Addendum #2

Project Name: Nebraska Innovation Campus - 4H Building Renovation & NIC Office Building.
Project No.: 11053
Issued: November 13, 2012
Bid Date: Tuesday, November 20th, 2012
Bid Opening: 2:00pm – Private Opening
Location: 728 Q Street Suite C, Lincoln, NE 68508

G1/A500
 Bid Package 02
 Addendum 02

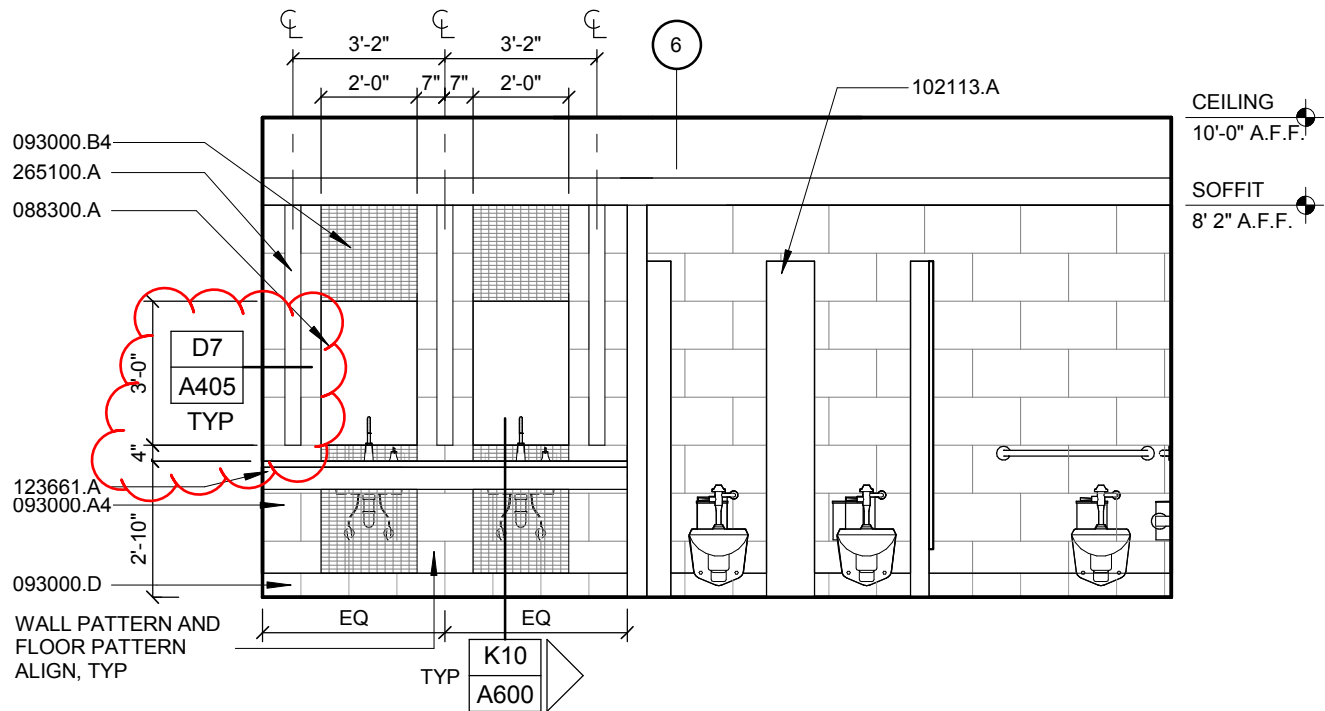
- a. Refer to exterior South Elevation L1: Add aluminum window frame type AW-11 east of grid e7 and west of mechanical louvers. See attachment G1/A500

A10

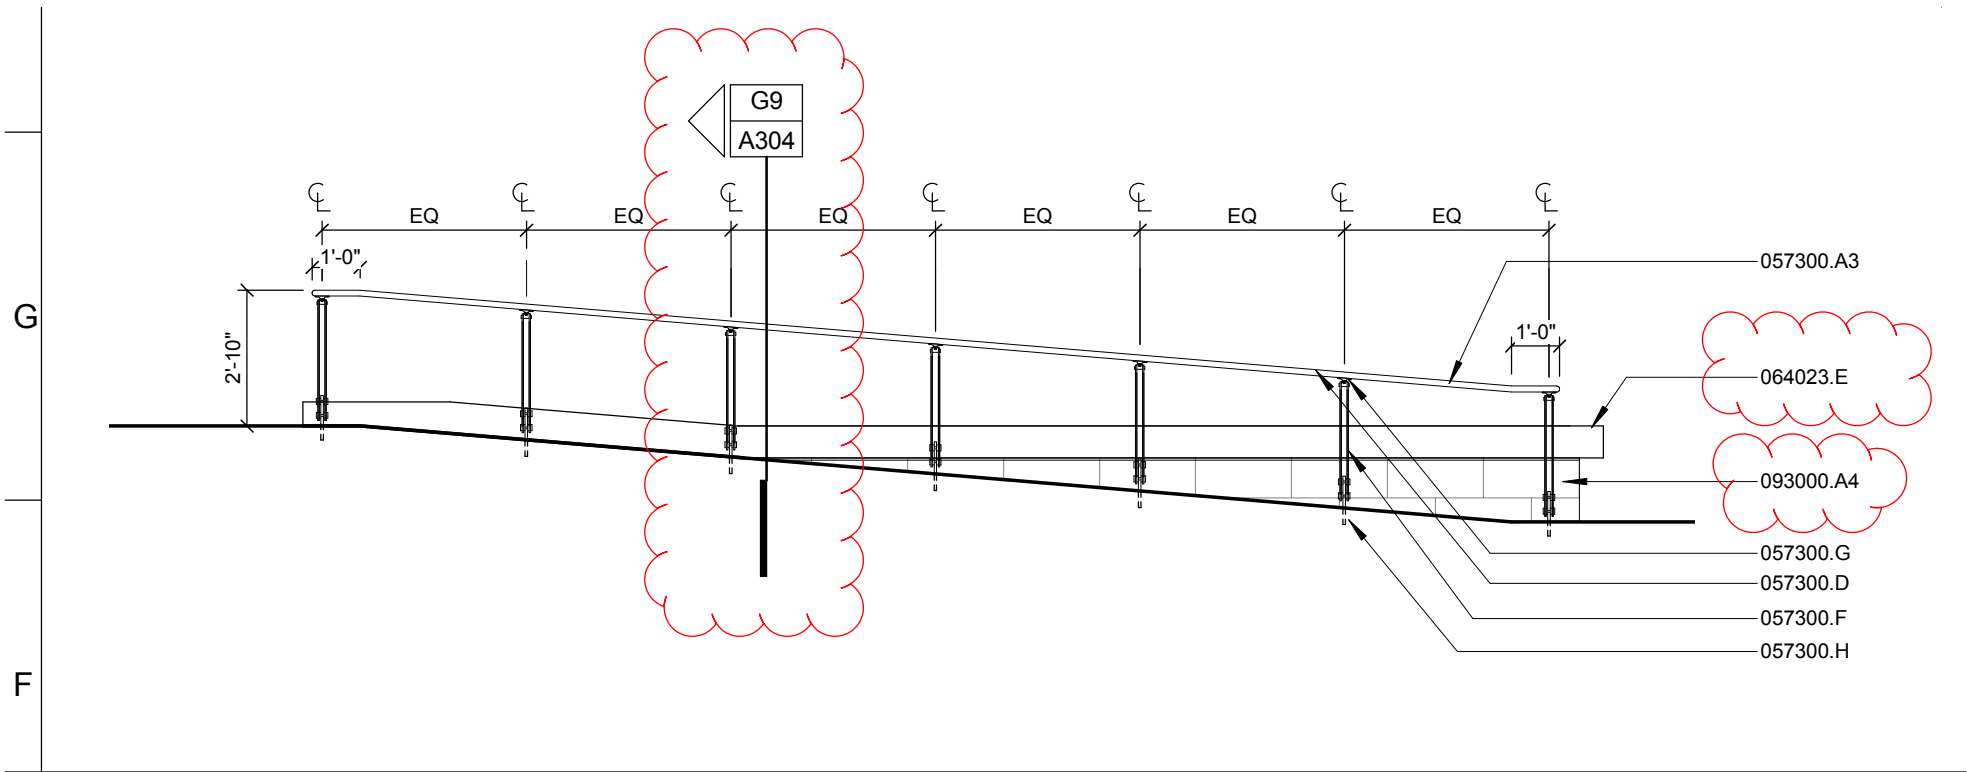
- a. Adjusted tile pattern to coordinate with 5'-0" recessed light fixture in Restrooms, Area D. See attached sketch A10/A512.
- b. Modified keynotes, notes, and added detail section of bench between ramp and stair in Link. See attached sketch N5/A512.
- c. Modified keynotes and added detail section of bench between ramp and stair in Link. See attached sketch F1/A512.

Reference: D1/A513
 Bid Package 02
Addendum 02
 4H Renovation & NIC Building

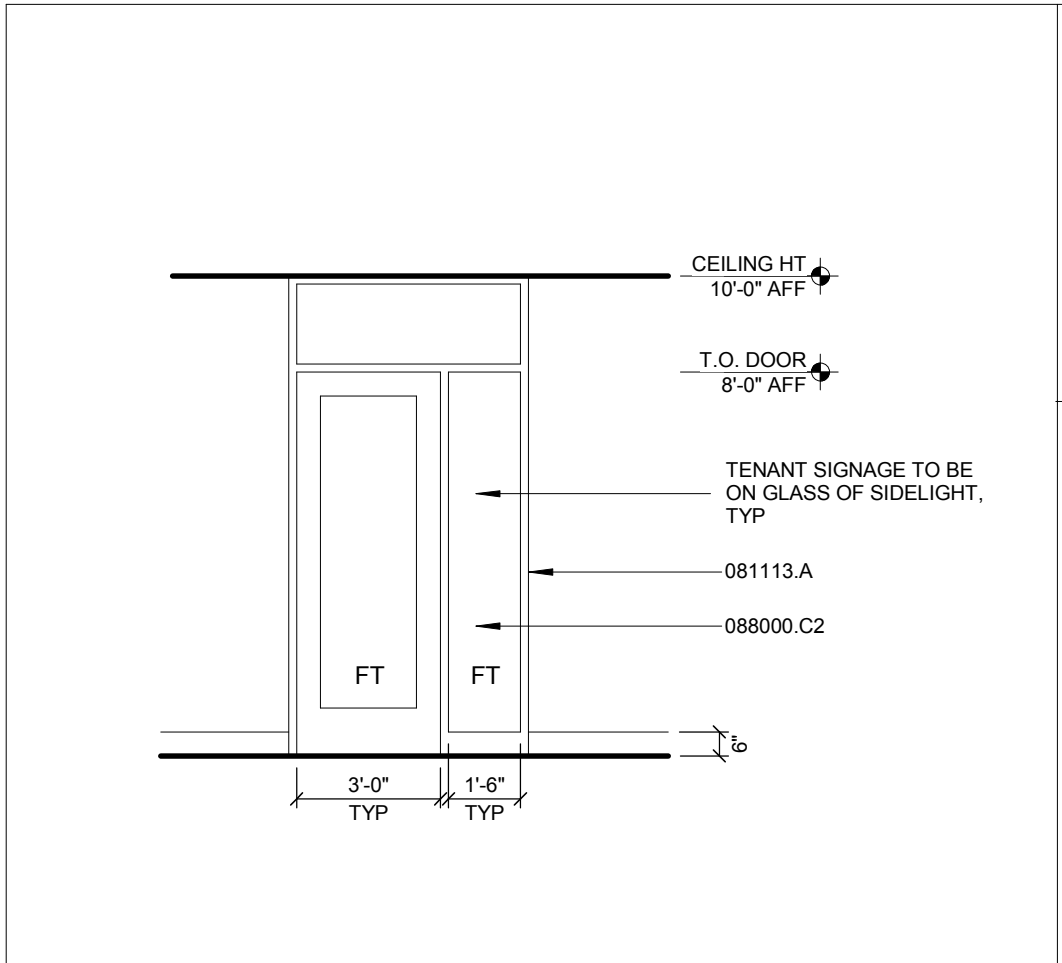
- a. G16/A513, modified joint pattern in wood paneling. Added detail tags. See attached sketch.
- b. D1/A513, modified joint pattern in wood paneling. Added detail tags. See attached sketch.
- c. Added interior elevation G12/A513 of future typical tenant entrance. See attached sketch.

Attachment: S10
 Reference: 16/S503CD
 Bid Package: 02
 Addendum: 02

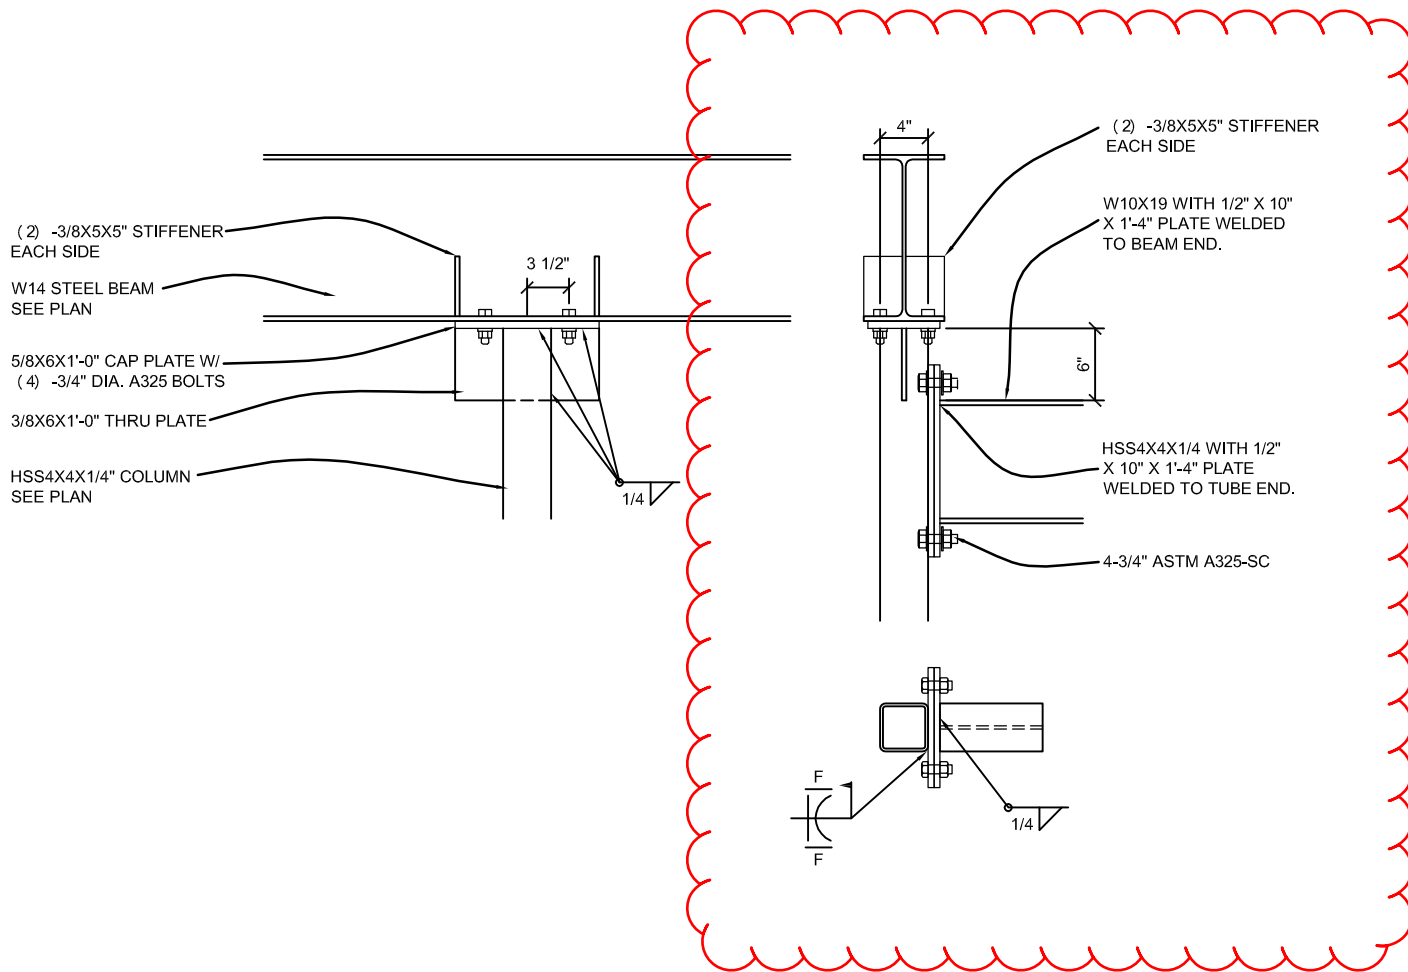
- a. See attached Sketch S10. This is a new detail indicating attachment of columns for screen wall around cooling tower.
- b. See attached Sketch S13. This is a new detail indicating the roof support at the south end of area C. This is typical for the lower and upper roof.
- c. See attached Sketch S14. This is a new detail indicating the floor support at the south end of area C.

Attachment: S11
 Reference: 3/S504CD
 Bid Package: 02
 Addendum: 02

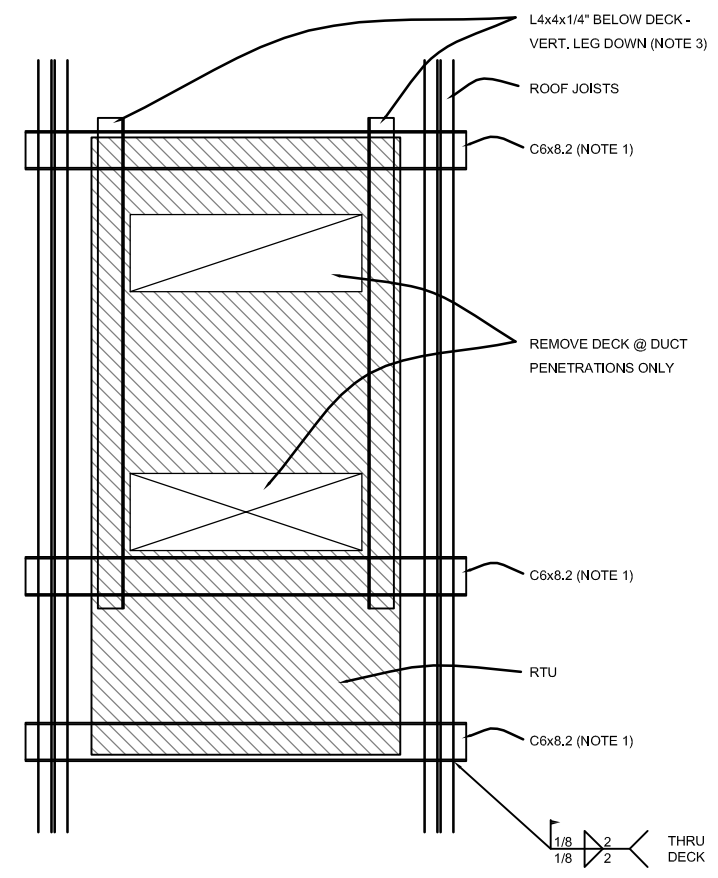
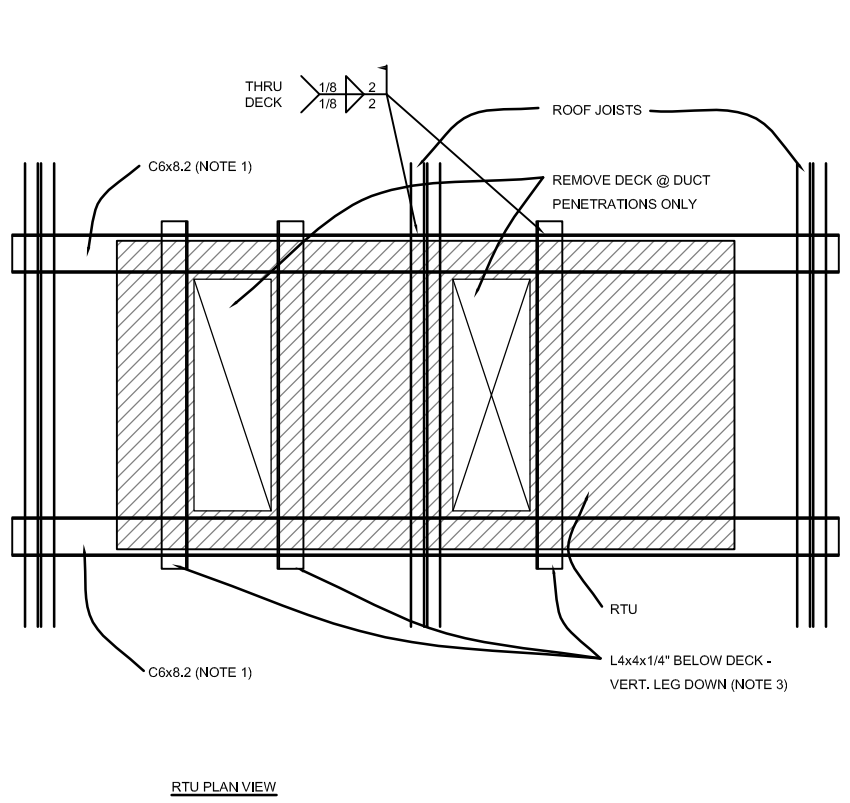
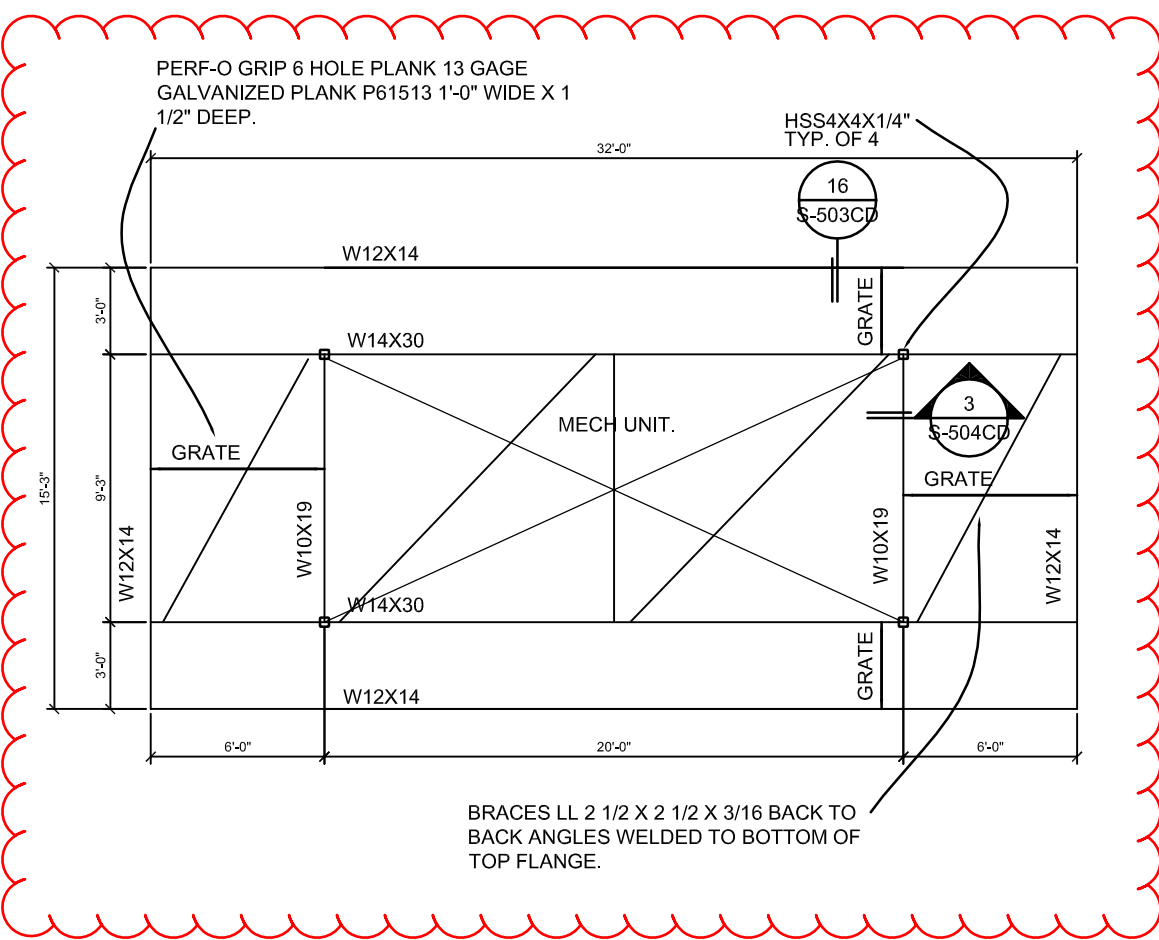
- a. See attached Sketch S11. Note revisions to the detail for connecting the beam to the column.
- b. See attached Sketch S12. Note additional information (grate note, detail mark) added to the detail and revisions to the dimensions. The sketch is on 11x17 paper and was plotted to fit on the 11x17 paper.
- c. See attached Sketch S16. Note dimension revisions and revisions to beam size.

- 1 L4X4X5/16
- 1A L4X4X5/16 - REMOVE
- 2 L3X3X1/4
- 2A L3X3X1/4 - REMOVE
- 3 LL3X2 1/2X14
- 3A LL3X2 1/2X1/4 - REMOVE

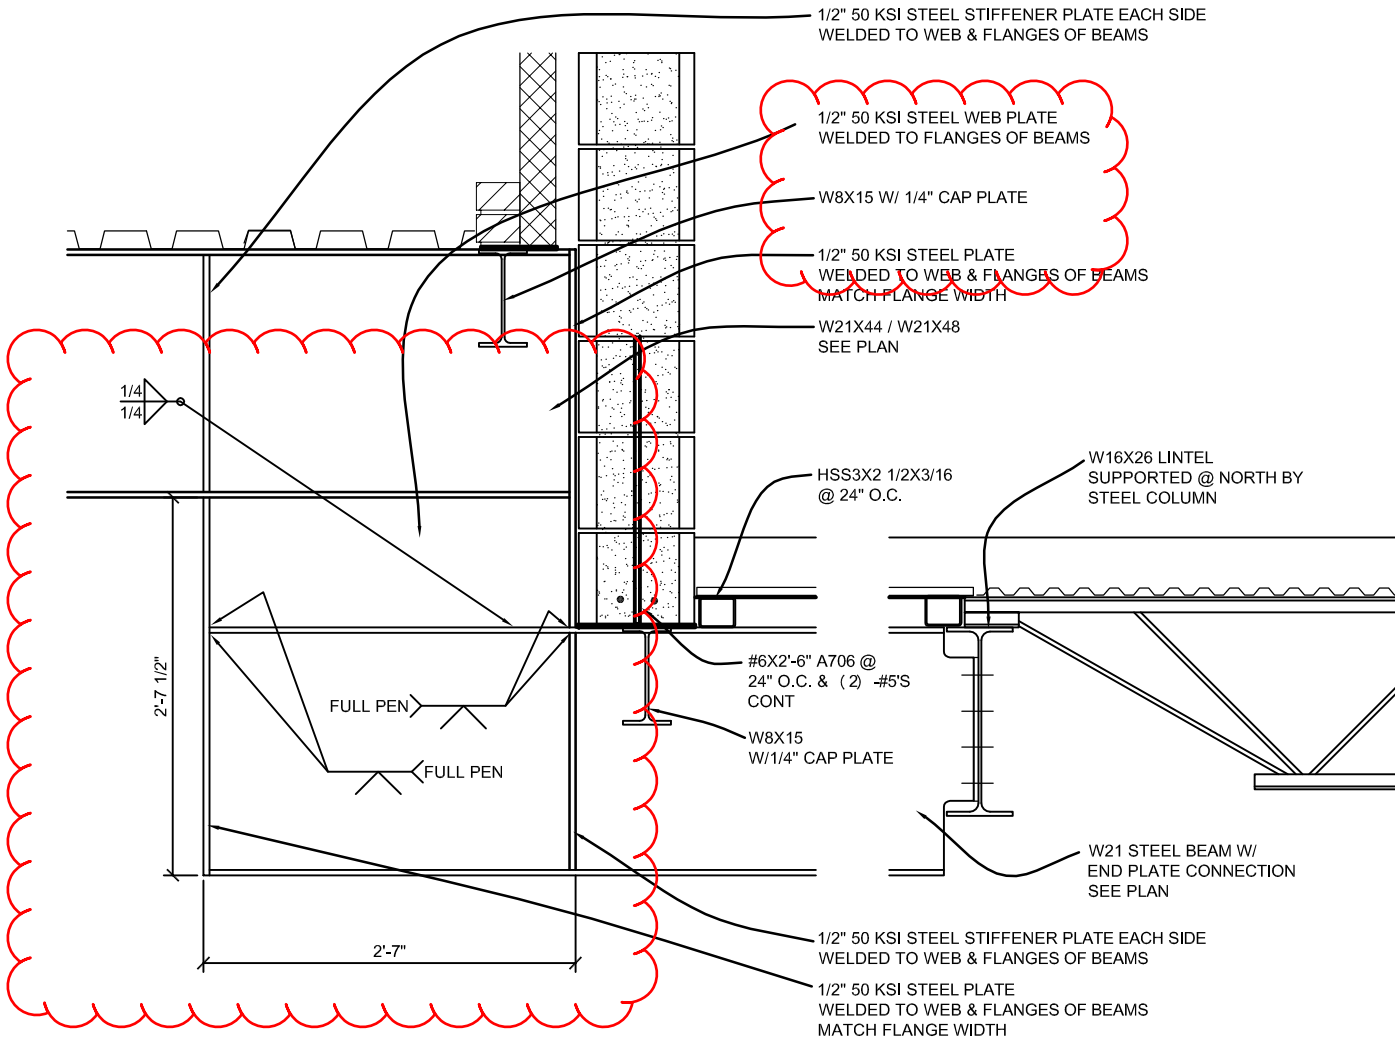
- a. See attached sketch S15. This is a new detail indicating the existing bridging members to be removed at grid eD between grids e13 and e14. This detail will apply at grid eC between grids e13 and e14. The existing framing members are arranged in a similar fashion, but are not the same as those at grid eD. Dimensions and actual existing members will need to be verified in the field at both locations.
